Access Compliance Report Public Rights-of-Way (Curb Ramps)

Main Street: PACIFIC_AVE Cross Street: DIXIE_DR Location: NW

ADA ID: RPRK210922131056 Ramp Type: Type 1 - Perpendicular Diagonal Initial Pass/Fail: Fail Overall Compliance: No Severity Score: 30

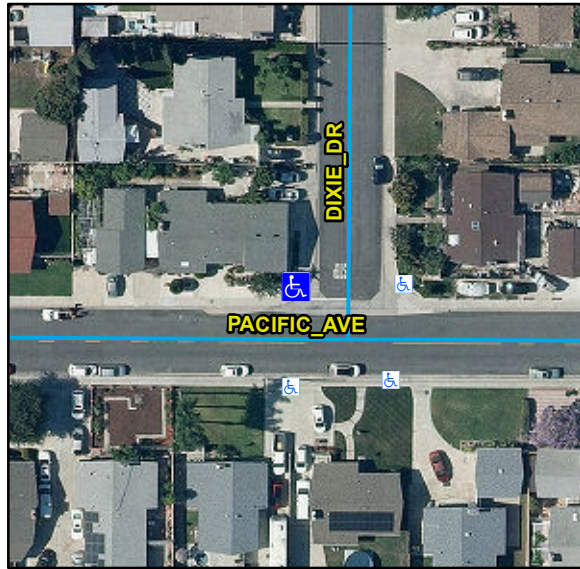
Compliance	Description	Data	Compliance	Description	Data
N/A	Ramp Length (in)	50	N/A	Flare Type LT	
Yes	Ramp Width (in)	48			N/A
No	Ramp Run Slope (%)	15.3	N/A	Flare Slope LT (%)	N/A
Yes	Ramp Cross Slope (%)	1.6	N/A	Flare Traversable LT	N/A
N/A	Landing Present	N/A	N/A	Flare Type RT	
N/A	Landing Length (in)	N/A			N/A
N/A	Landing Width (in)	N/A	N/A	Flare Slope RT (%)	N/A
N/A	Landing Run Slope (%)	N/A	N/A	Flare Traversable RT	N/A
N/A	Landing Cross Slope (%)	N/A	N/A	DWS Provided	N/A
N/A	Landing Movement Obstructed?	N/A	N/A	DWS Contrast	N/A
	Landing Movement Type	N/A	N/A	DWS Length (in)	N/A
N/A	Landing Shared	N/A	N/A	DWS Full Width	N/A
N/A	Clear Space	Yes	N/A	DWS Offset Left (in)	N/A
N/A	Clear Space To Crosswalk (in)	N/A	N/A	DWS Offset Right (in)	N/A
N/A	Marked Crosswalk 1	No	N/A	Marked Crosswalk 2	No
	Crossing 1 Direction	S		Crossing 2 Direction	E
	Marked Crosswalk 1 Width (in)	N/A		Marked Crosswalk 2 Width (in)	N/A

Remove & Replace Curb Ramp With Two New Directional Ramps or Equivalent.
